SERVICE BULLETIN

APPLICABILITY: 2013MY BRZ

NUMBER: 03-71-13

SUBJECT: 6MT Shifter Rattle and Improvement to Reverse Pull Collar Operation

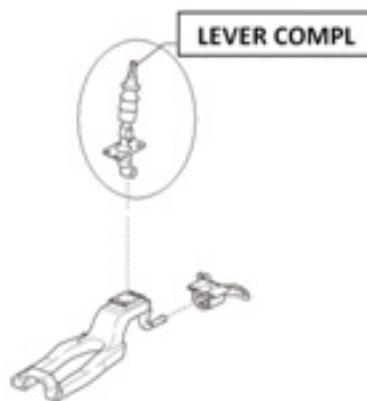
This Bulletin announces availability of a revised 6MT shifter lever and an enhancement to the reverse pull collar assembly designed to improve the operation of the reverse selection mechanism. In addition, this new assembly will eliminate a rattle sound from the shifter which may occur primarily in 3rd gear between 3500 and 6000 rpm. While the rattle condition is most noticeable in the listed gear and rpm range, it may in rare cases be noticeable under other conditions.

The new shift lever was incorporated into production in December, 2012 starting with VIN: D2605967.

PART NAME	PART NUMBER
Lever Compl	35011CA010

Once the customer's concern has been confirmed to be associated with the shift lever, replace the lever assembly following the service procedure outlined in the applicable Service Manual.
